MEMORANDUM

REVIEW TYPE: Preliminary Plan Review

APPLYING FOR: Resubdivision of Lot 10 and 11, Block 6 - Ridgewood Village

CASE #: 1-04034

PRELIMINARY PLAN
PROPOSED LOTS 14 & 15, BLOCK 6
RIDGEWOOD VILLAGE

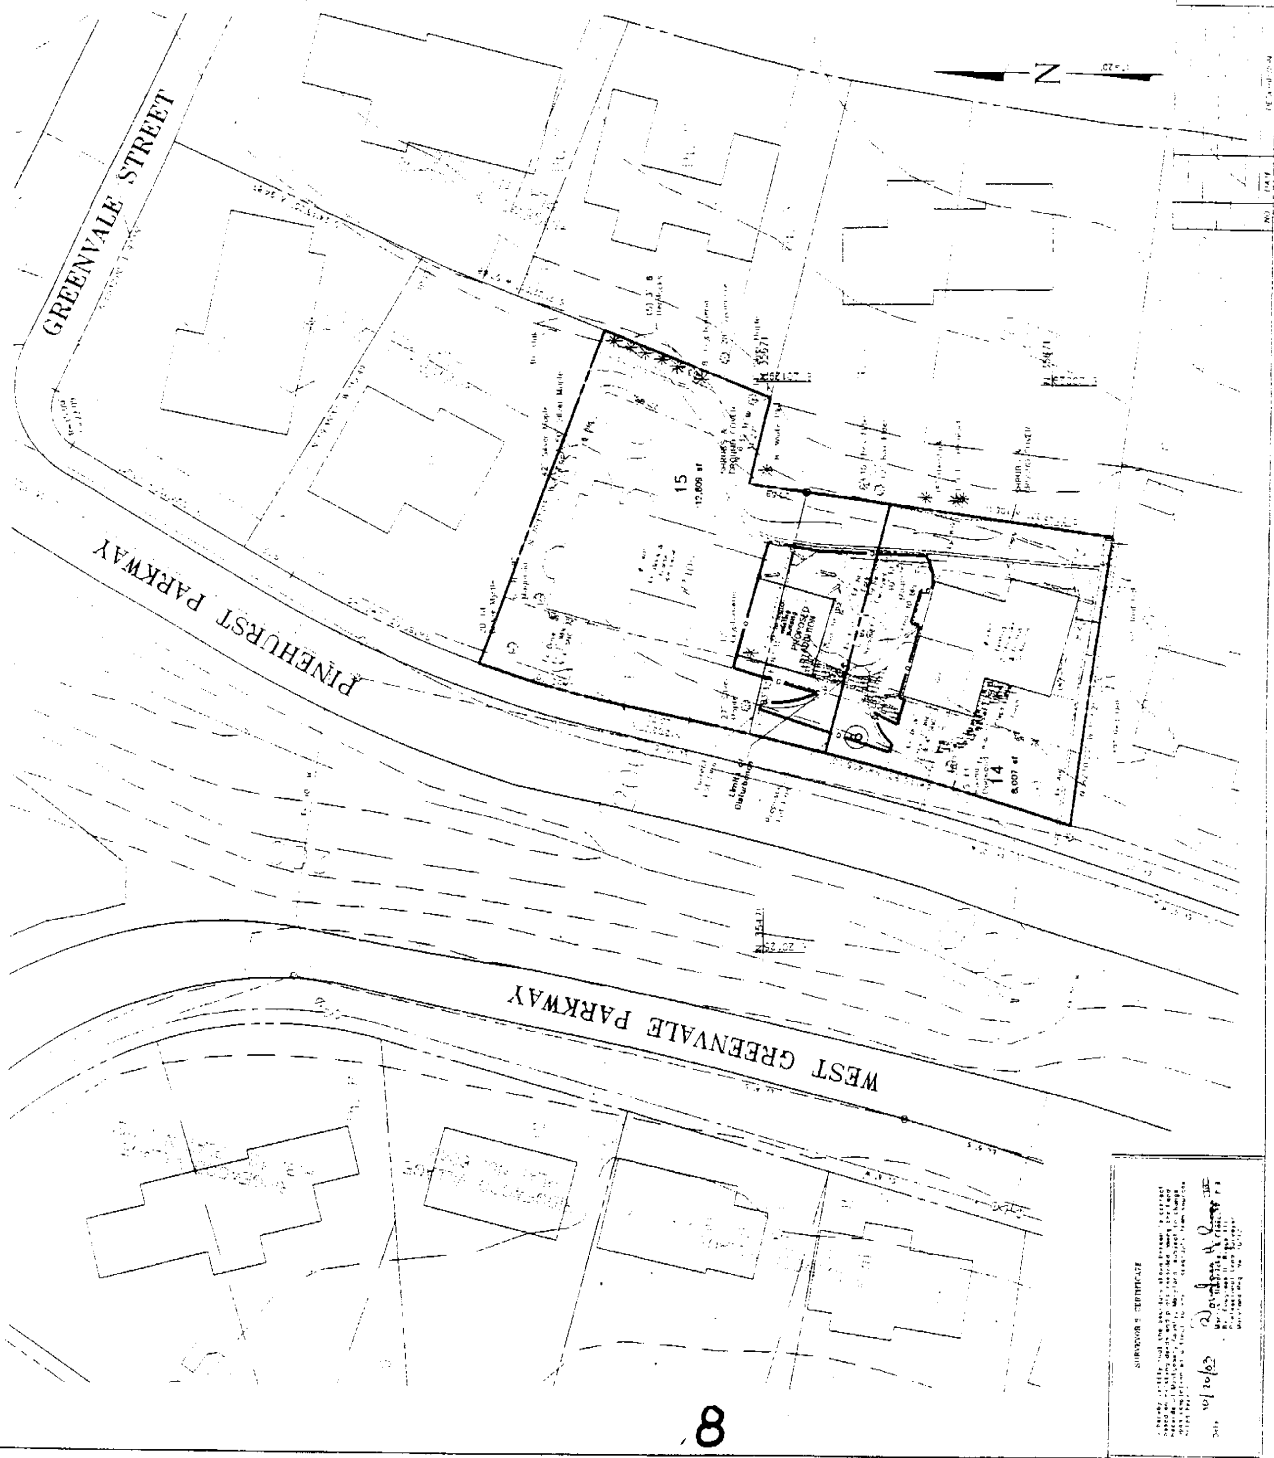
This application for resubdivision proposes to shift the dividing lot line between the two subject lots 28 ft. to accommodate the necessary area and setback for an addition to an existing single family residence on proposed Lot 15. Had this lot line shift involved less than 5% of the total area of the two lots, this would have qualified as a minor lot line adjustment. However, in order to shift the lot line to gain the necessary area and setback for the addition, the “5% rule” for a minor lot line adjustment was not possible. This lot line shift does not create additional lots; rather, it results in two lots with modified sizes, areas, frontages and widths. Shape, alignment and suitability remain unchanged from existing conditions.

As stated above, the approval of this subdivision application would not result in the creation of new lots. The proposed lots differ from the existing lots only in relation to size, area, width, and frontage. Shape, alignment and suitability remain relatively unchanged. The new lots will have the following characteristics (*Respective to proposed Lots 15 and 14*): **Size** – 12,808 sq. ft. and 8,007 sq. ft.; **Area** – 6,190 sq. ft. and 3,398 sq. ft.; **Width** –122.78 ft. and 86.6 ft.; **Frontage** – 125.26 ft. and 89.38 ft. Staff has reviewed the new lots for consistency with the neighborhood characteristics and has shown these relationships in the attached tabular summary.

- 1) Applicant to submit a detailed tree save and grading plan for staff review and approval prior to recordation of plats
- 2) Compliance with conditions of MCDPWT letter dated December 5, 2003, unless otherwise amended
- 3) This preliminary plan will remain valid for thirty-seven (37) months from the date of mailing of the Planning Board opinion. Prior to this date, a final record plat must be recorded for all property delineated on the approved preliminary plan, or a request for an extension must be filed
- 4) Other necessary easements
